Re: Geotechnical Advisory Board

The fifth meeting of the Geotechnical Advisory Board was convened in Panama from February 22-26, 1993. The schedule for this meeting is included with this report as Attachment A.

Mr. Numan H. Vasquez, February 26, 1993  
Subject: Geotechnical Advisory Board

Fig. 1 Design Chart for tensile strength of concrete (Raphael 1984)

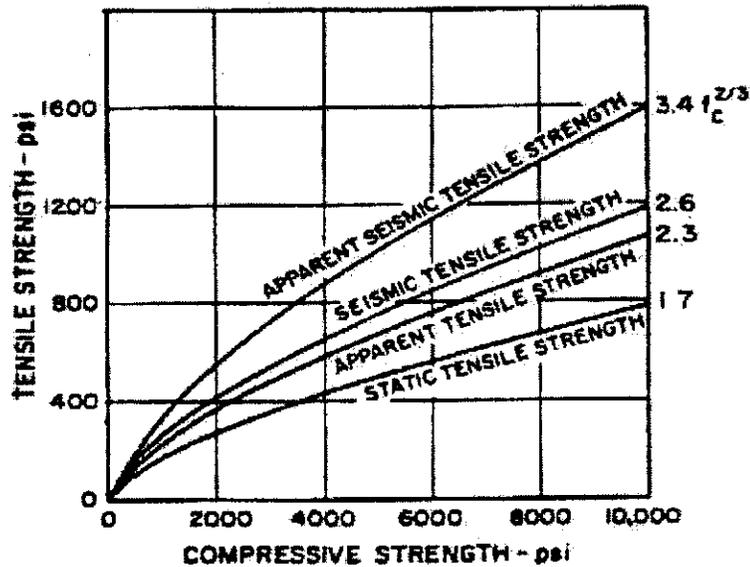
The 200-psi value for tensile strength of concrete is especially conservative because it is based on tests conducted at slow rates of loading. This value can be modified to account for the increase in concrete strength at rates of loading representative of earthquake conditions to determine the "seismic tensile strength". The common practice is to modify this tensile strength value further to account for the nonlinearity of the stress-strain relation near failure of concrete before using it to interpret the stresses computed by linear dynamic analysis. As can be seen from the recommended design charts in Figure. 1, these two effects double the estimated tensile strength from  $1.7 f_c^{2/3}$  to  $3.4 f_c^{2/3}$ , where  $f_c$  is the compressive strength. Thus 400 psi could possibly be

justified for the tensile strength of the Gatun Spillway concrete. To confirm and refine this estimate if desired, splitting tension tests should be conducted under dynamic conditions with 0.04 sec as the time to failure; this value is based on the present computations of the vibration period of the spillway. Perhaps some of the concrete cores could be tested at WES to obtain independent data.

In summary, Gatun Spillway is expected to withstand the ground motion considered without any significant cracking of concrete. This conclusion is based on an evaluation that is conservative in two respects: the tensile strength of concrete is underestimated and the contribution of the curved plan to the structural capacity is not considered. However, this conclusion is limited to the main body of the dam; possible sliding displacements at the dam-rock interface or the performance of the rock underlying the spillway during an earthquake have not been evaluated. Similarly, the seismic safety of the intake structure, including the wall immediately upstream of the intake structure, and of the concrete walls at the interface between the spillway structures and the Gatun embankments remain to be evaluated.
